DRAINAGE PLAN
STA. 145+00 TO 150+00

FARRINGTON HIGHWAY INTERSECTION IMPROVEMENTS
AT NANAKULI AVENUE AND HALEAKALA AVENUE
Federal-Aid Project No. STP-093-1(22)

CONTRACT CHANGE ORDER NO. 27
Attachment 1

DRAINAGE PROFILES - 6

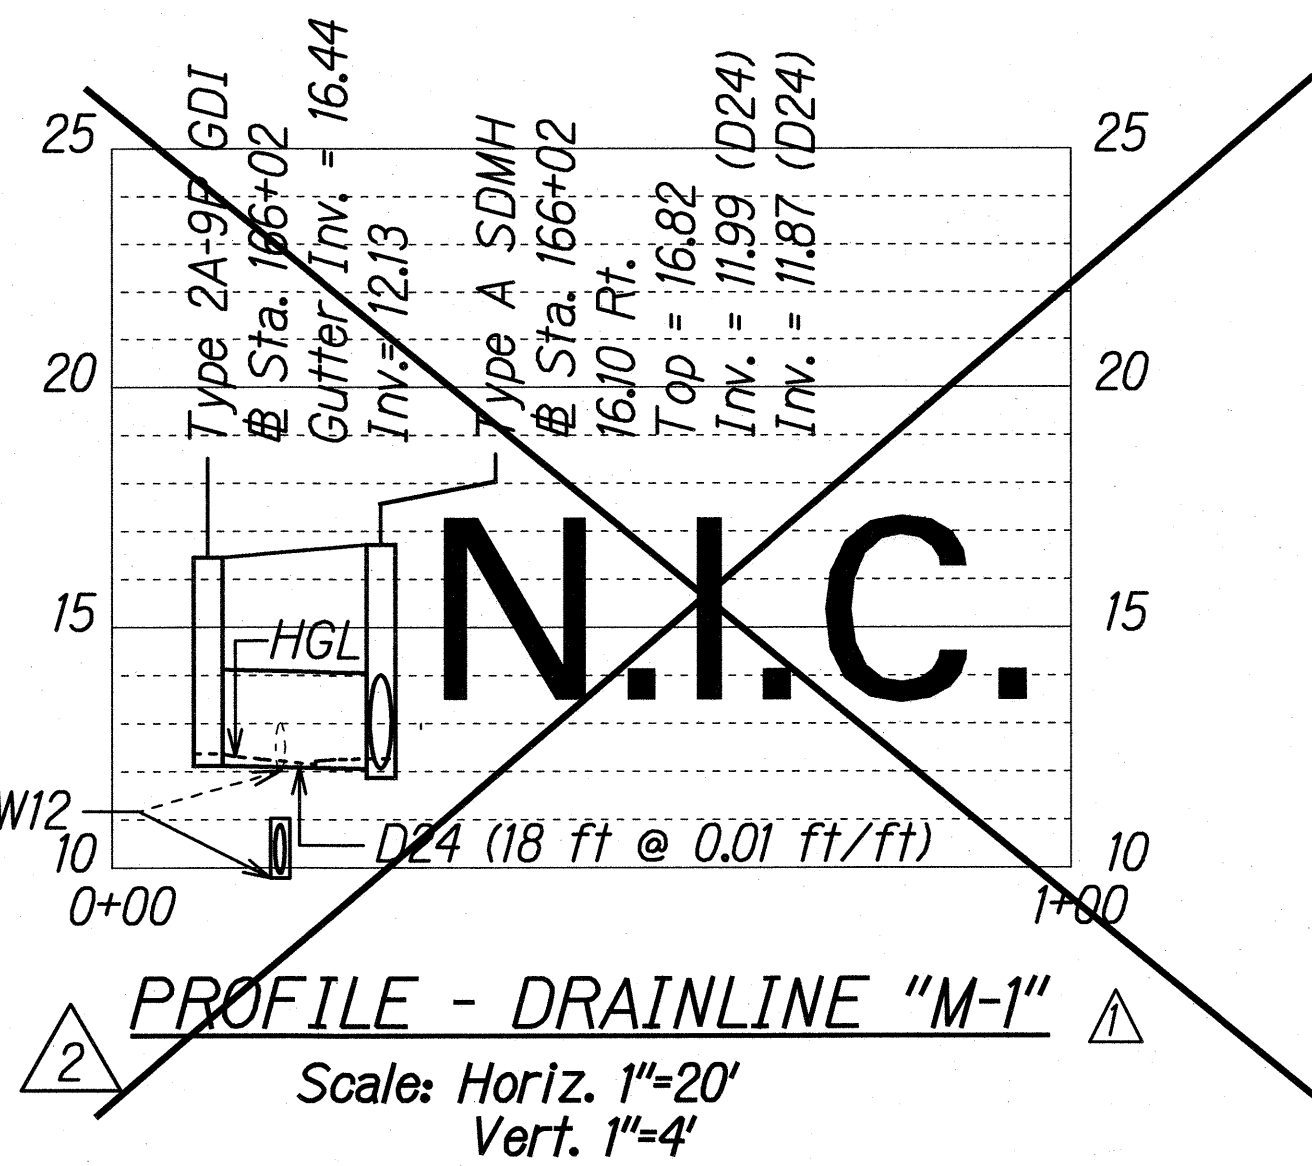
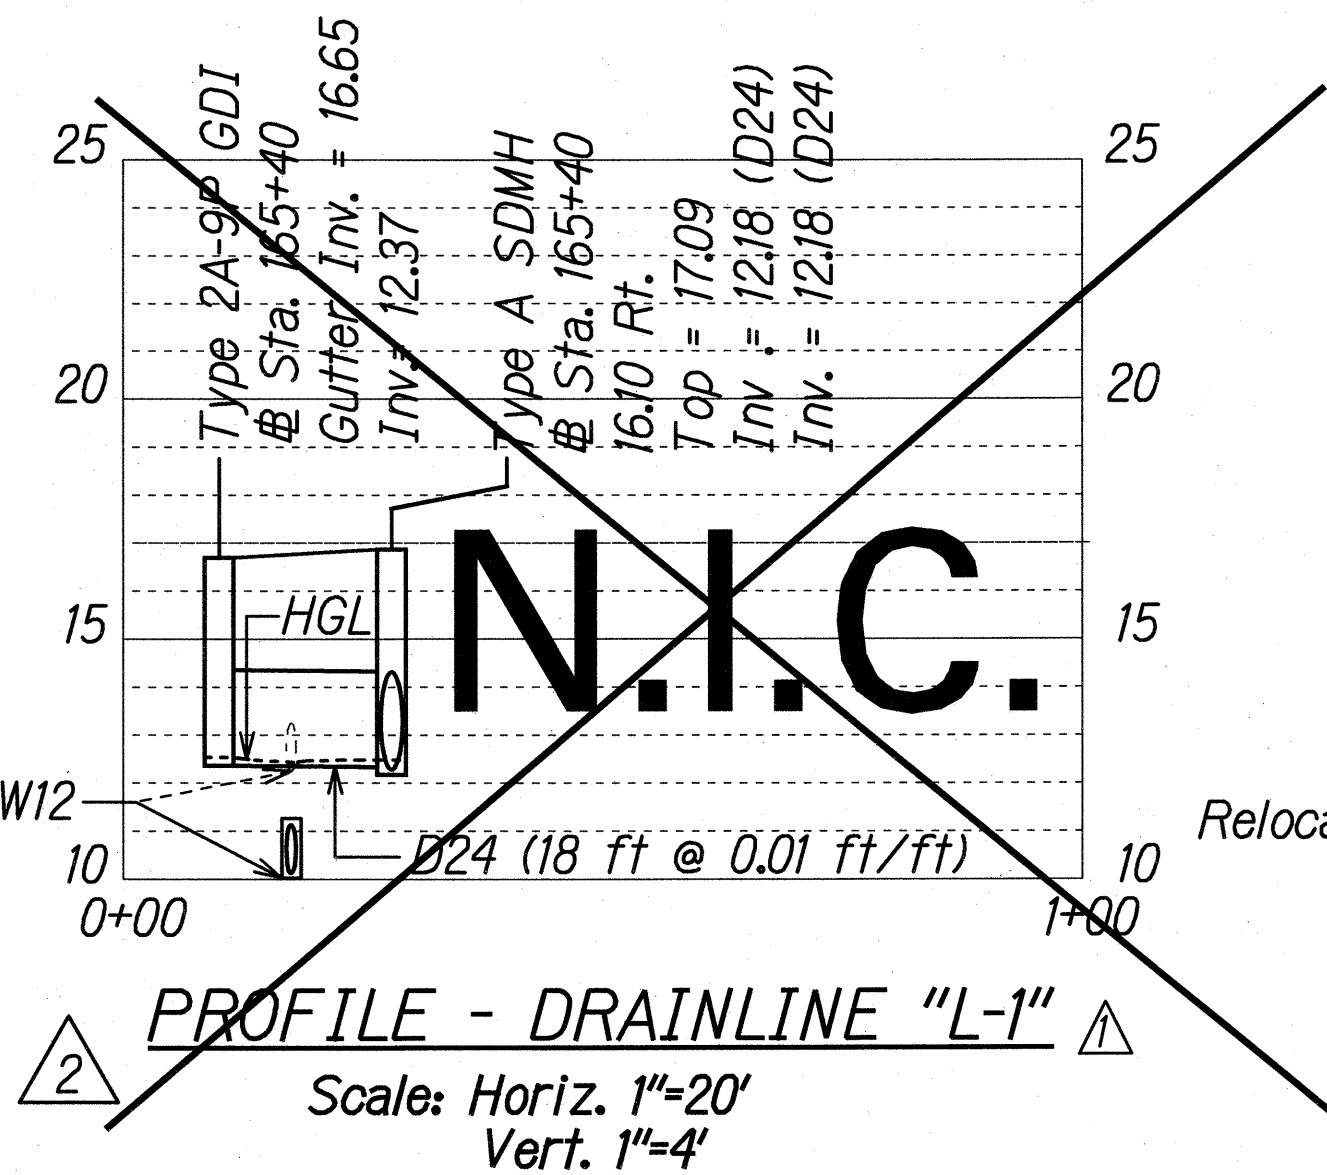
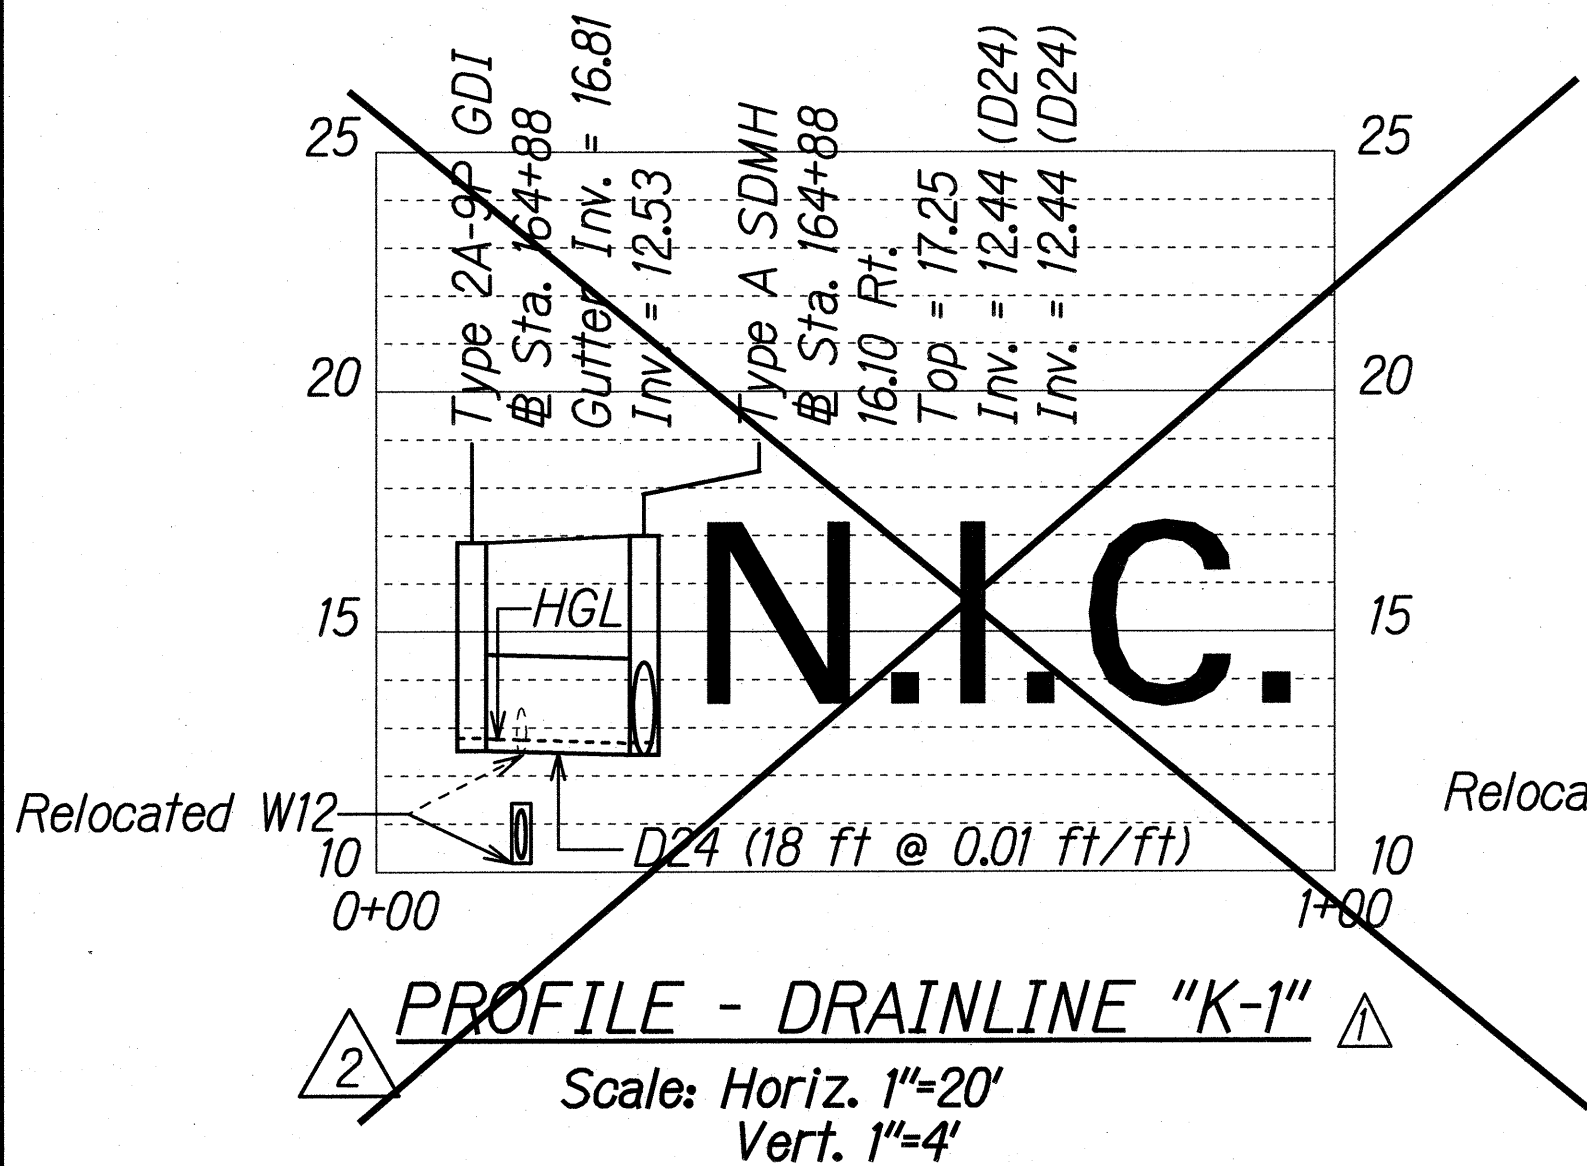
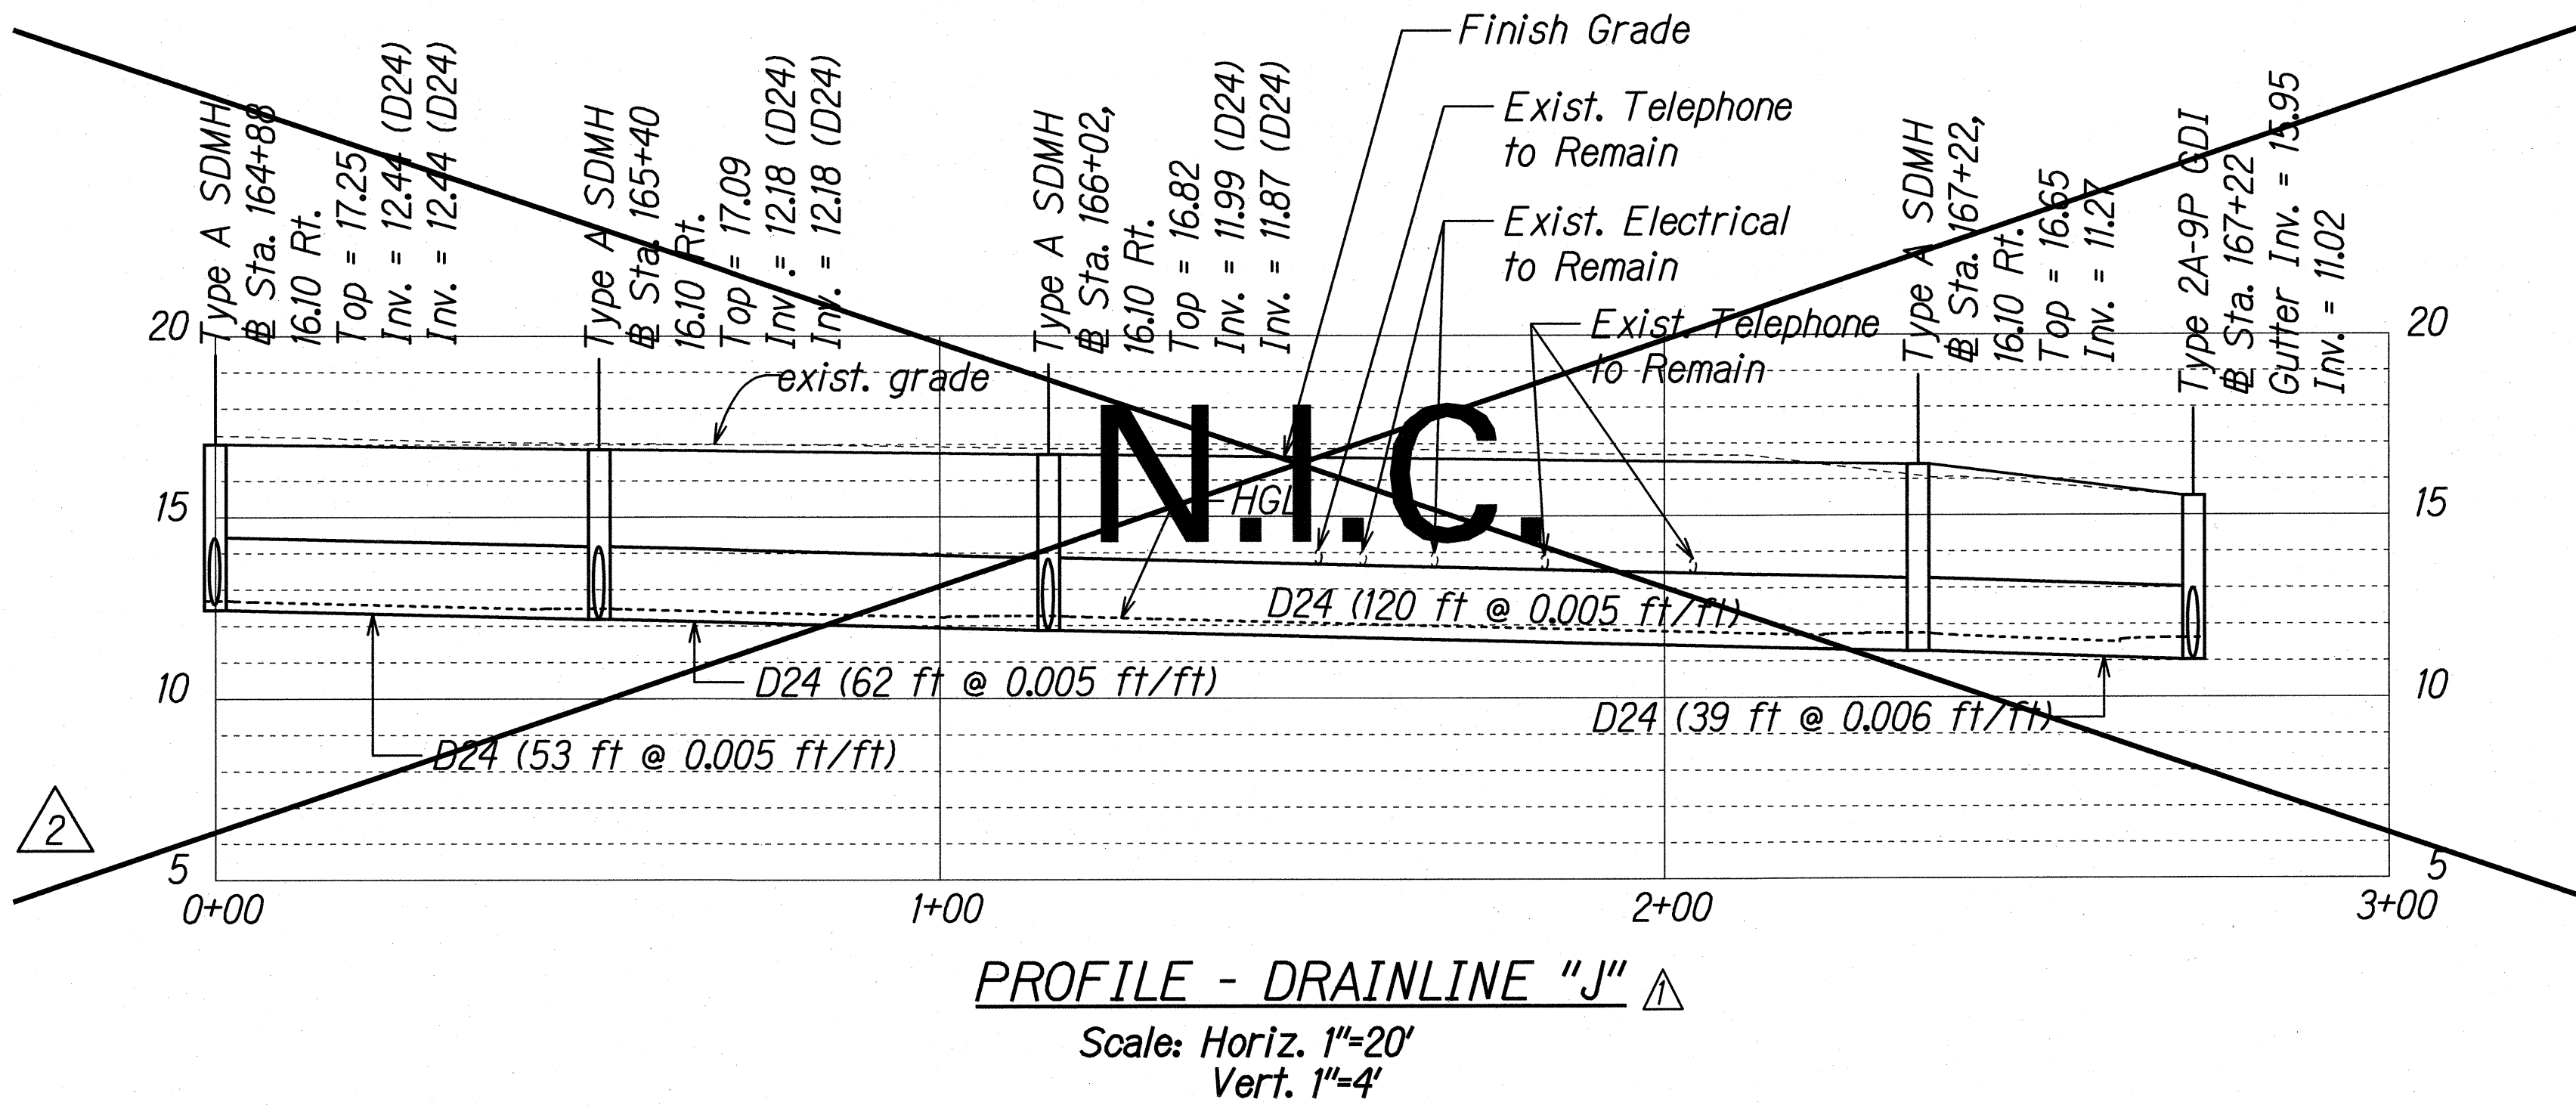
11/17/17	Revised Drainline "H-1"
8/7/17	Deleted Profiles
4/22/15	Revised Drainline "H-1", "J", "K-1", "L-1" & "M-1"
DATE	REVISION
